**Project**  
17 John Street

**Drawing Title**  
Proposed Section

PL-06

Section as approved in application 2017/2552/P  
Variations to approved scheme as clouded

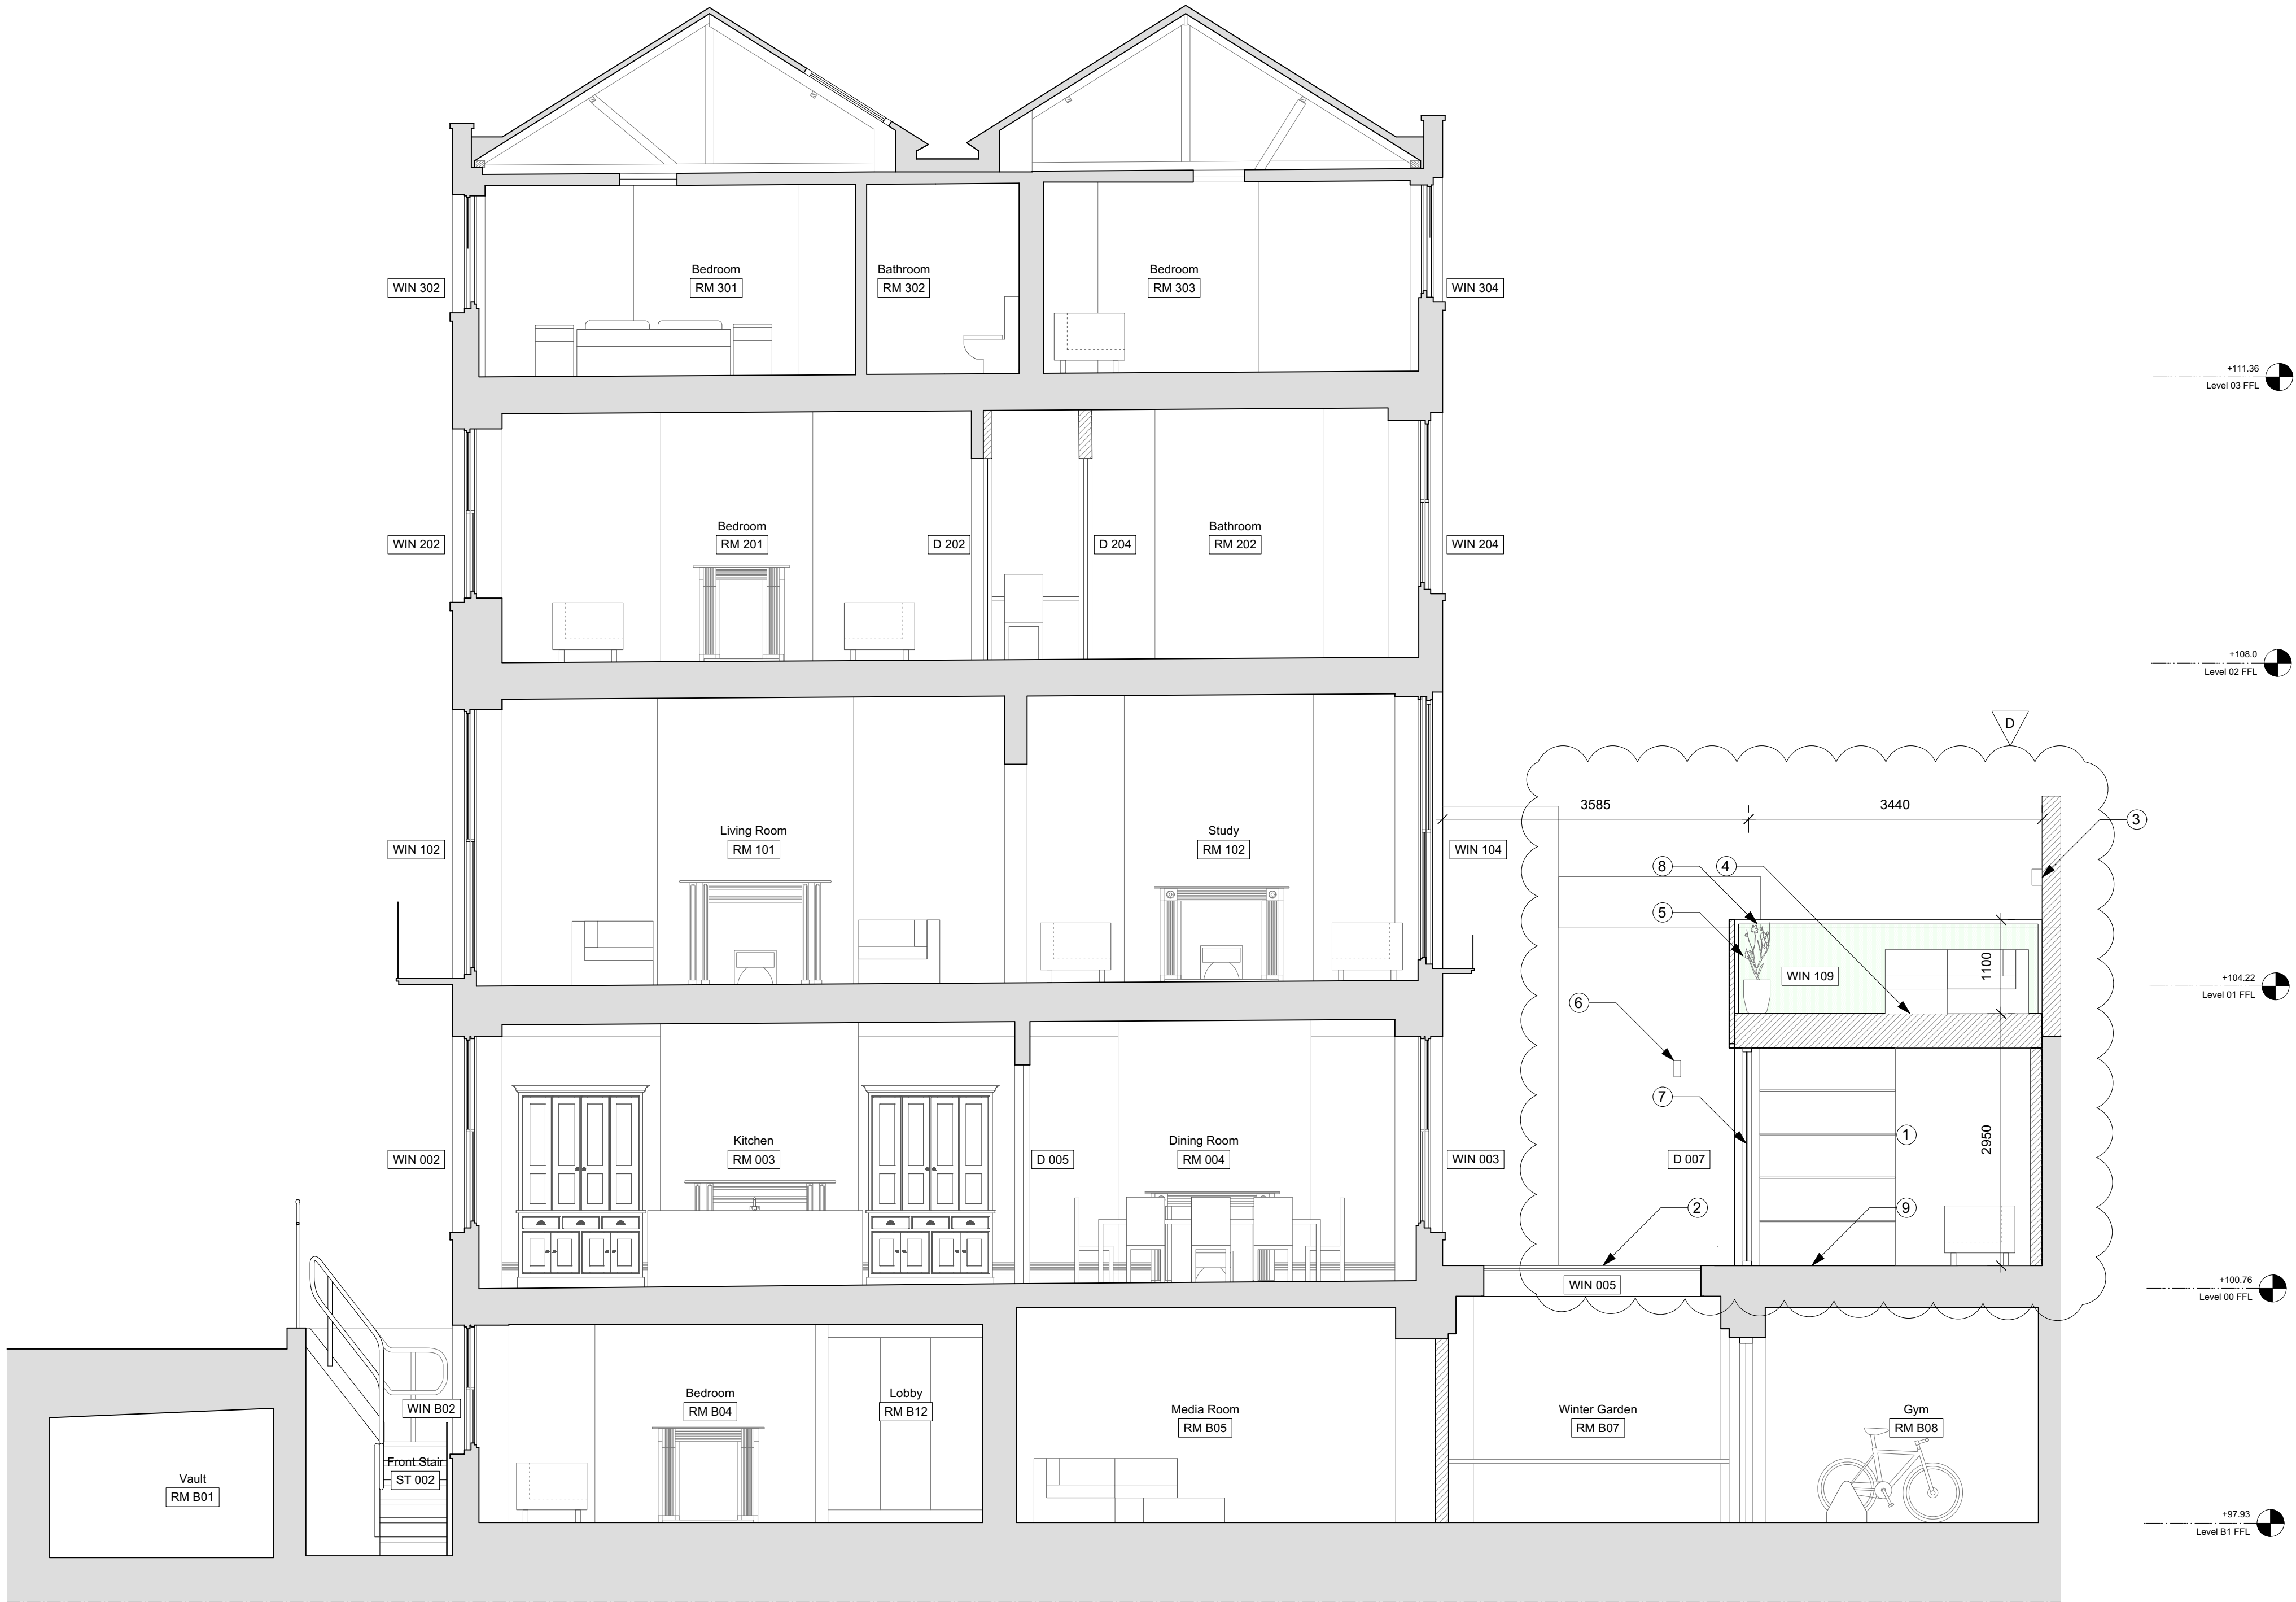
1. Fitted joinery and timber lined wall
2. New walk on roof light
3. 2no. new discrete lighting fixtures to roof terrace, fixed to rear garden wall
4. Stone flooring or similar to new terrace
5. PPC metal balustrade
6. Replace 6no. existing external wall mounted lighting with 1no. new wall mounted light fixture by stair entrance
7. Double glazed full height swing doors
8. New raised 1100 rooflight to boundary
9. Stone flooring or similar to extension
